MEMORANDUM

RE: Planning Department Recommendations

Please find attached, for your information, Planning Department recommendations for the November 18, 2025 Board of Appeal's Hearing.

Also included are the Board Memos for:
75 to 77 Dorchester ST South Boston 02127
80 Smith ST Mission Hill 02120
100 Smith ST Mission Hill 02120

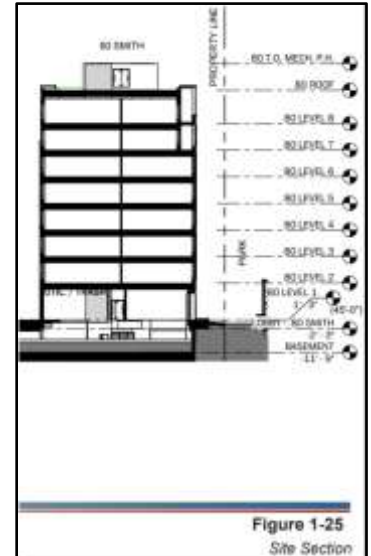
Side Yard Setback Zoning does not require a side yard setback. *Figure 1-16 Site Sections between 80 Smith and Mission Hill Playground* shows various widths of the side yard setback, including a planted buffer and the “porch” area. However, a portion of this setback is shown as a walkway, not as a planted buffer in renderings. This area also includes the fence that is not shown on renderings. *The design of this setback and interface should be clarified.*

Figure 1-25 Site Section appears to show 80 Smith Street in relation to the property line. This section does not include height or setback width as it changes along the facade. It does not show balconies, private yards or landscaping and trees. *This information should be provided.*

The plans indicate that there will be a landscaped buffer between the building at 80 Smith Street and the playground. The plans show eight trees in this buffer. However, even the site plan shows the tree canopies to be severely truncated. It is unclear whether the trees proposed in this buffer would be viable. *Further detail should be provided.*
